COUNCIL ASSESSMENT REPORT

SNPP No	PPSSNH-17
DA Number	LDA 2019/0264
Local Government Area	City of Ryde
Proposed Development	<p>Concept master plan proposal for the redevelopment of 122-126 Herring Road, Macquarie Park comprising:</p> <ul style="list-style-type: none"> • Building envelopes to accommodate a maximum gross floor area (GFA) of 60,633m²; • Provision of basement car parking across the site and • Road infrastructure, a publicly accessible open space area and public domain layout / concept design.
Street Address	122 - 126 Herring Road, Macquarie Park (Morling College)
Applicant/owner	<p>Morling College (Association of Baptist Churches of NSW & ACT) C/ Urbis P/L</p> <p>Owner: Baptist Churches of NSW & ACT</p>
Date of Lodgement	9 August 2019
Number of Submissions	280 individual submissions & 3 separate petitions containing a total of 114 signatures were received objecting to the proposal. This includes a submission which was sent directly to the SNPP.

List all documents submitted with this report for the panel's consideration	Attachment 1: Draft Conditions of consent Attachment 2: Apartment Design Guideline Table.
Report prepared by	Sandra McCarry Senior Town Planner
Report

Figure 25: Original design with loading bay setback 3m

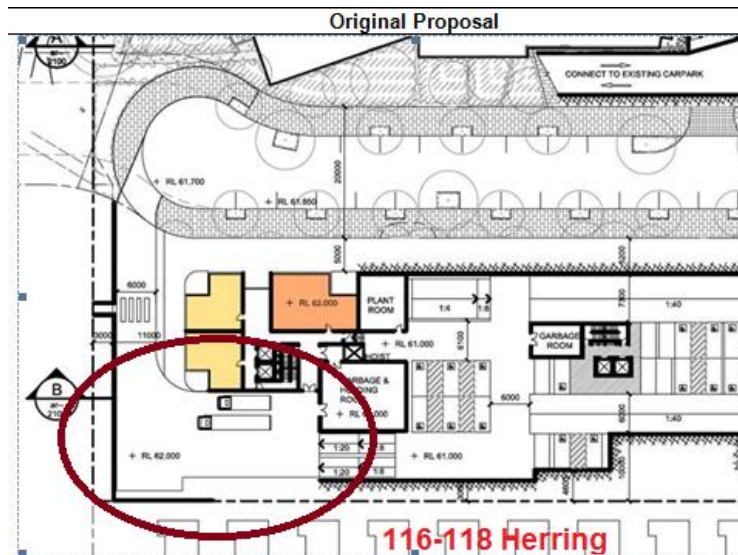
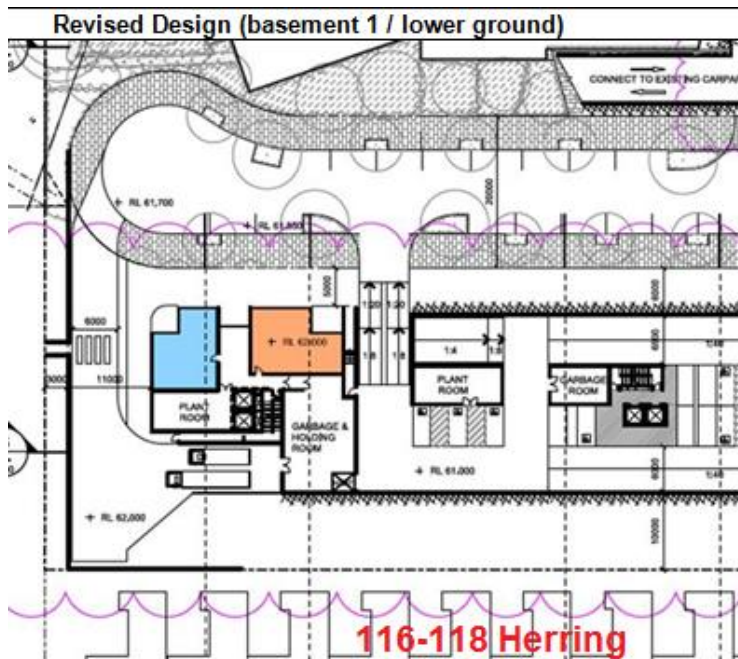
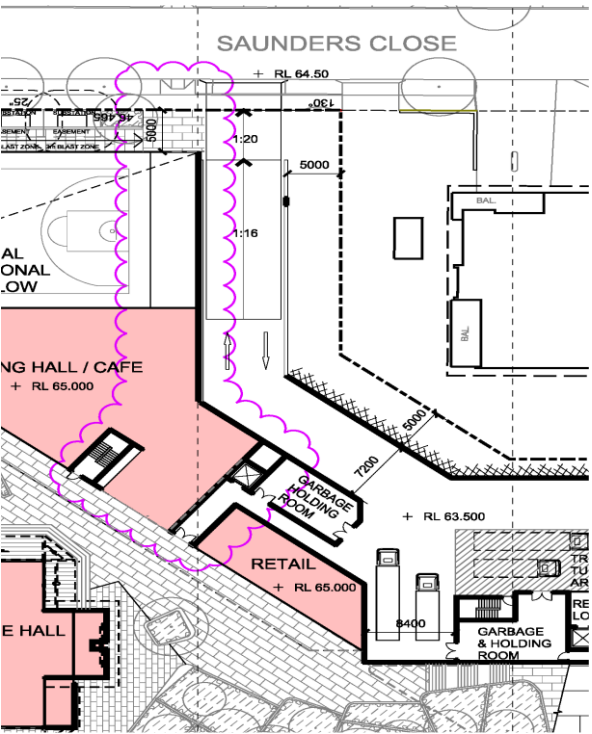
SEPP 65 – Design Quality of Residential Flat Buildings	UDRP Comments	Council Comment
	<p>distribution <i>A retail or mixed use frontage is still shown to the ground level of the new college buildings north of the new road. An area for dining or other uses external to the building is shown to the north which is positive. However large areas for seating are also shown to the south which the Panel questions?</i></p> <p><i>During discussions in the meeting the applicant mentioned these uses may be commercial in which case this concern would no longer arise.</i></p> <p>Staging <i>- Information on staging to ensure the new road is delivered early in the development of the site. (UDRP previous comments from 21 March 2019).</i></p> <p><i>Additional information was tabled which suggests that the 3 large residential towers to the south of the site would be delivered ahead of further buildings for the college. The new road is shown as being part of these works which is positive. However the Panel is concerned that this part of the site could be sold and developed separately to the remainder of the master plan, which could create awkward relationships to the other existing Morling buildings. Therefore, staging should consider how the campus will function if the southern part of the site is redeveloped independently.</i></p>	<p>Herring Road frontage and retail distribution The applicant has advised that there are opportunities for the lower levels of Buildings 1 & 2 to potentially be used as commercial office spaces. These activated seating areas provide an outdoor "break out space" for future tenants and employees.</p> <p>Staging The applicant has advised that the exact sequencing of construction staging is currently unknown however in the submitted Statement of Environment Effects, it provided "Development Scenarios" where regardless of which Precinct is constructed first, the new road or sections of the road will be delivered as part of the development for each precinct.</p> <p>The construction of the road is required to service the respective buildings, with the exception of Building 2. Accordingly, if Building 2 was to be constructed first, independently of Building 1, Condition 32 has been imposed requiring partial construction of the road (similar to scenario 4). This would not require demolition of existing dwellings on site and displace existing residents.</p>

Figure 26: Amended design with increase setback of 10m with a small section adjacent to the southern boundary.

Figure 28: Amended Building 4 envelope.

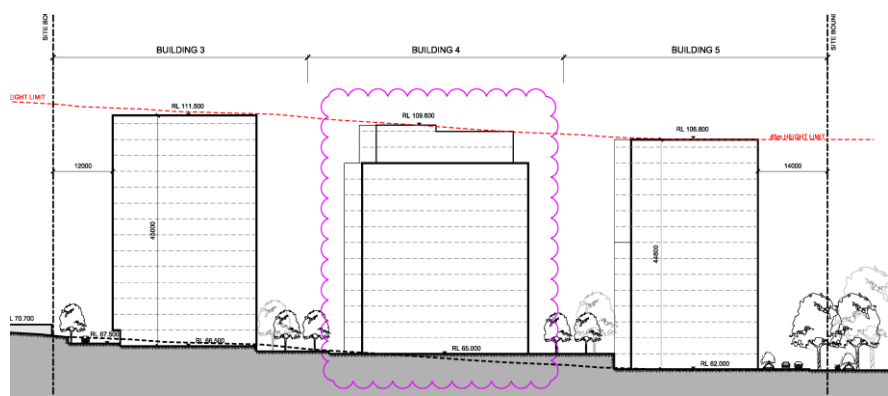
SEPP 65 – Design Quality of Residential Flat Buildings	UDRP Comments	Council Comment
and outlook.	<p><i>back further however there are a number of locations where the basements extend up to the proposed verge line. The applicant needs to ensure the relative levels of the verge and ground against the basement allow for a suitable depth and volume of soil to support landscaping and trees within the front setback without resorting to a full planter across this area.</i></p> <p><i>The Panel is also concerned about the indicative expression of the tower buildings and the ziggurat form for the central southern tower (Building 4). Ziggurat forms are not an ideal outcome and generally a maximum of one step in building form should be provided, unless it is to setback upper tower levels to give a defined top to the building.</i></p> <p><i>The Panel notes that none of the towers appear to resolve the top of the building and instead appear to have roof forms that are larger in footprint than the tower itself. This creates a very dominant massing that is not supported.</i></p>	<p>and the built form of the proposed towers is indicative only. Architectural expression, roof form and details will be provided at separate DA for each building. Notwithstanding this, the proposal amended the building envelope for Building 4 with a single setback to the upper levels of the tower, thus reducing the ziggurat expression of the built form (refer Figure 28).</p>

Figure 39: Suggested green pedestrian corridor off Herring Road, from Epping Road to eventually through to Macquarie University Metro Station at Waterloo Road.

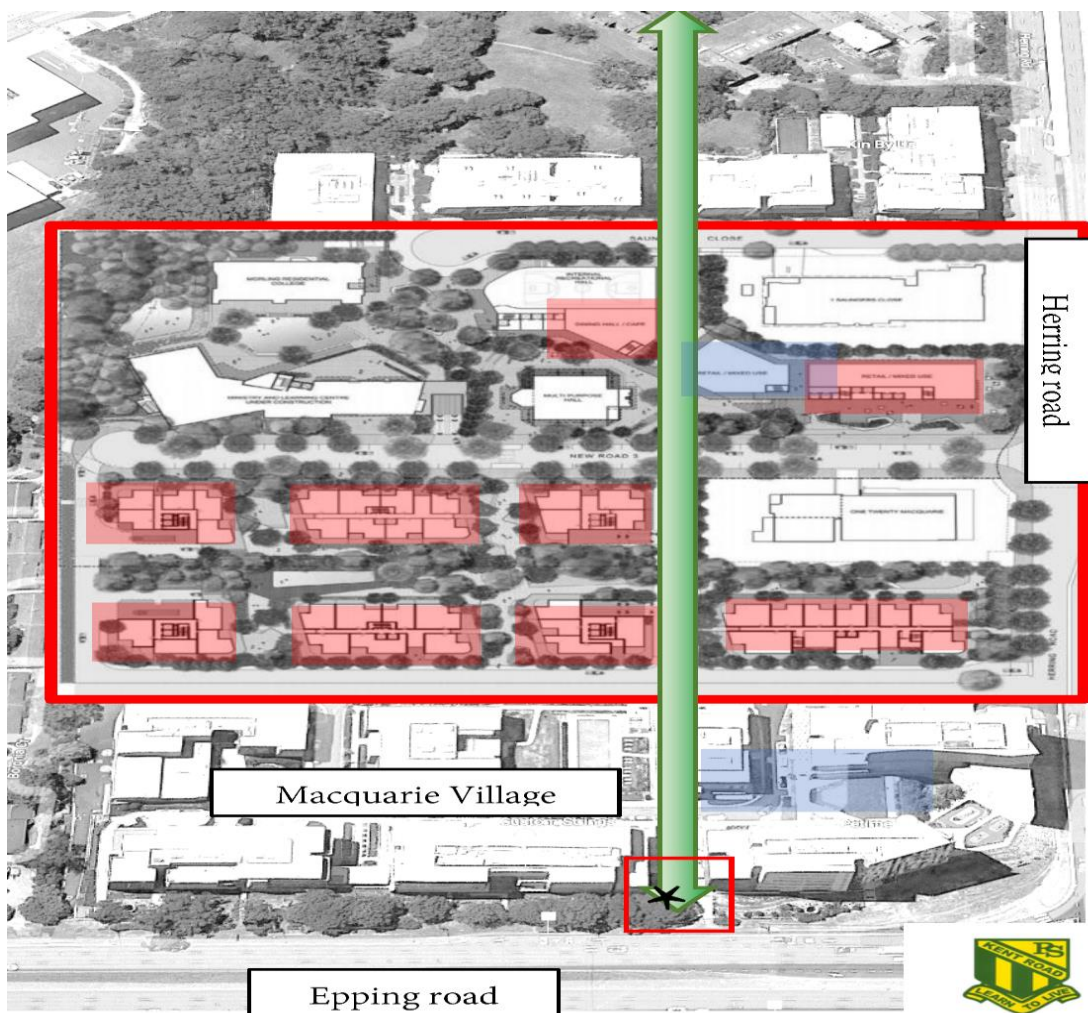
- *Poor pedestrian safety, the design overlooks the needs of the community to connect to local amenities, such as the local designated school (Kent Road School), and Metro station (Macquarie University Station).*

*To offset some of the effects of congestion, noise, limited public green space, the residents of the Herring Road precinct, request that the design of the current application be modified to introduce a solution to the precinct challenges - a green pedestrian corridor for the whole precinct, See **Figure 39**. This pedestrian corridor must be integrated into the current plan, given the proposed plan concerns a block of land (Morling College block) that is both is both central and large within the precinct.*

Whilst the north-south pathway is not a 12m wide straight continuous pathway as suggested by the objectors in **Figure 39**, nonetheless a pedestrian access is provided which provide connectivity from 116 – 118 Herring Road through to Saunders Close. This pathway is between Buildings 3 & 4, adjacent to the new proposed open space area and through the Village Green open space area through to Saunders Close. All publicly accessible areas throughout the site will need to comply with the relevant standards in accordance with AS 1428.1, BCA and Disability Discrimination Act.

The proposed pedestrian link suggested in **Figure 39**, starting from Epping Road to Macquarie University Metro Station at Waterloo Road cannot be easily achieved for the following reasons:

Figure 40: Pedestrian access throughout the site.

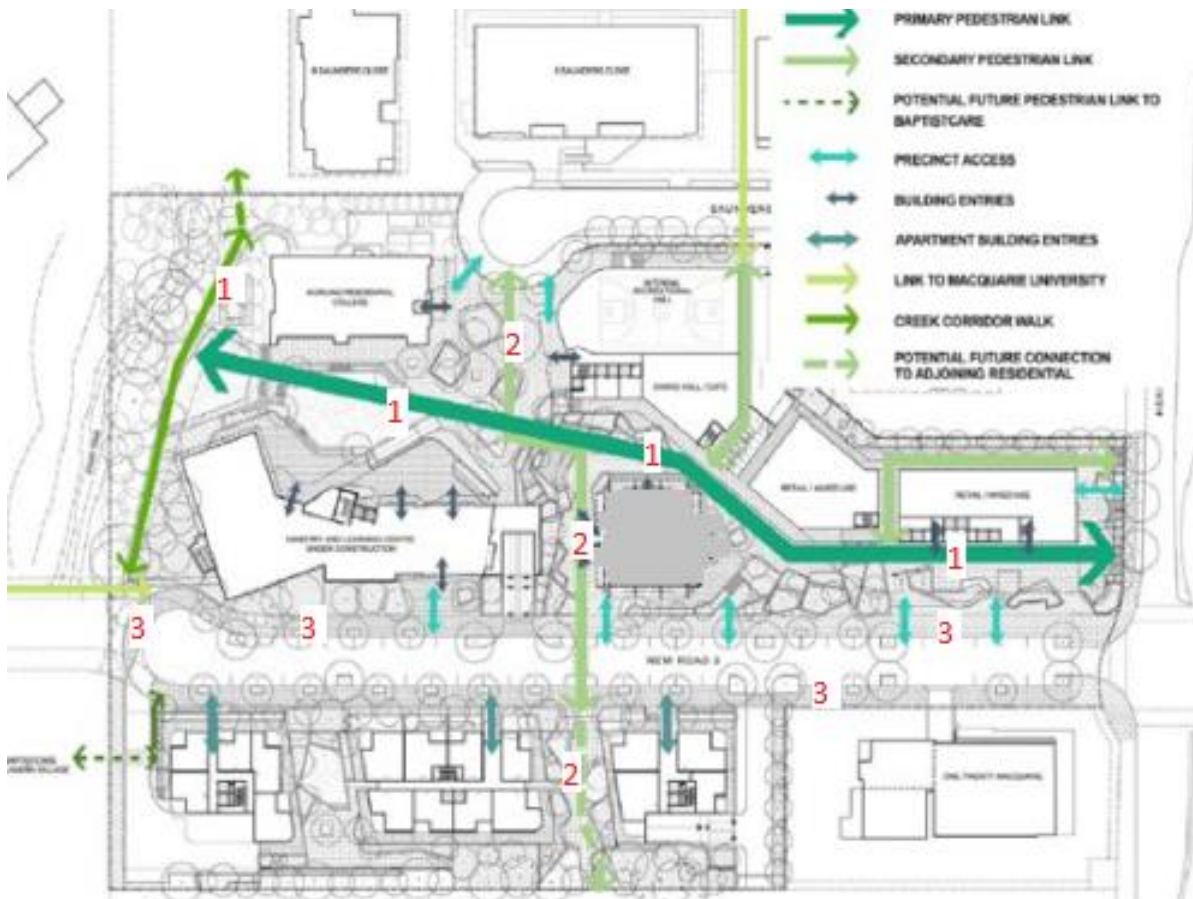
The subject site is a large privately owned parcel of land which is to be redeveloped to take up the height and FSR uplift endorsed by the Macquarie University Station Priority Precinct. As part of the concept application, it is proposed to construct a new road and provide pedestrian pathways as follows:

- A 20m wide road (Road 3) is to be constructed east to west from Herring Road to the western boundary. Future connection from the western boundary through to either the Macquarie University site or Baptist Care will eventually connect with Balaclava Road. The road will also provide pedestrian footpath on either side of the road. **Figure 40** below outlines the pedestrian links throughout the site. The new road is numbered “3” on the plan;
- An east west connection between Herring Road and the Kikkiya Creek riparian corridor (numbered “1” on the plan); and
- South to north from the southern boundary of 116 - 118 Herring Road (numbered “2”) to end of Saunders Close (refer **Figure 41**).

Figure 42: Extent of overshadowing at 12 noon by Building 1 of the Morling College to the Ivanhoe Estate outlined in red

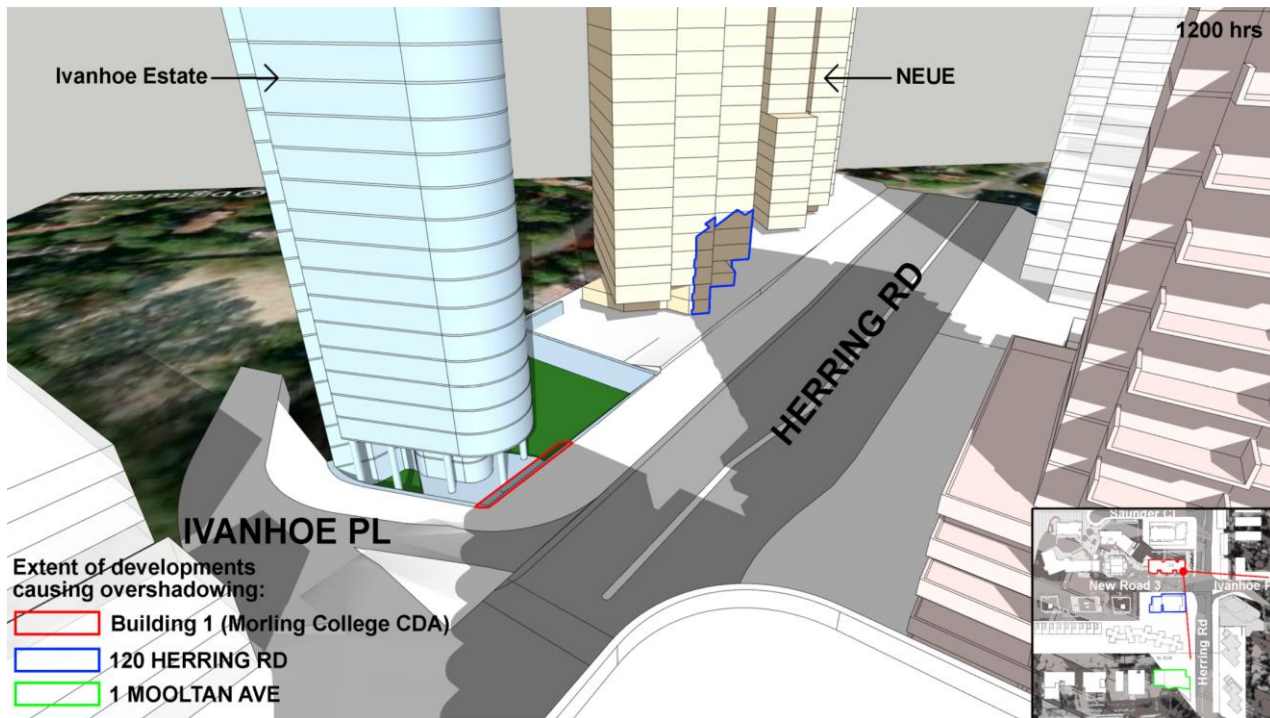
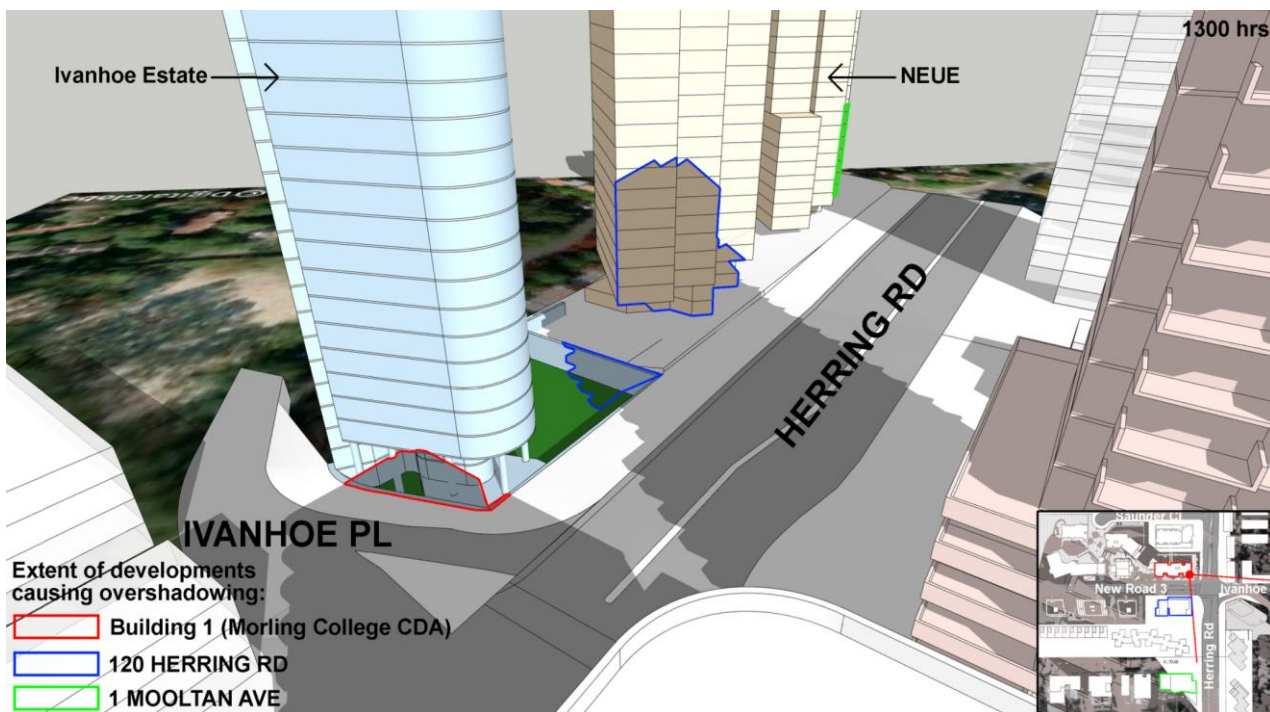
Additional shadow diagrams were submitted to determine overshadowing impacts from the proposal to Building A1 of the Ivanhoe Estate.

The shadow diagrams demonstrate that Building 1 of the Morling College, located at the south-east corner of the site adjacent Herring Road, causes minimal overshadowing to Building A1 at 12 pm and 1 pm on the 21 June. From 9am to 12pm and from 2pm to 3pm the proposal does not cast any additional shadow to Building A1. It is determined that the extent of shadow impact to Building A1 is minor, impacting upon the ground floor lobby area only, as illustrated in **Figures 42 & 43** below.
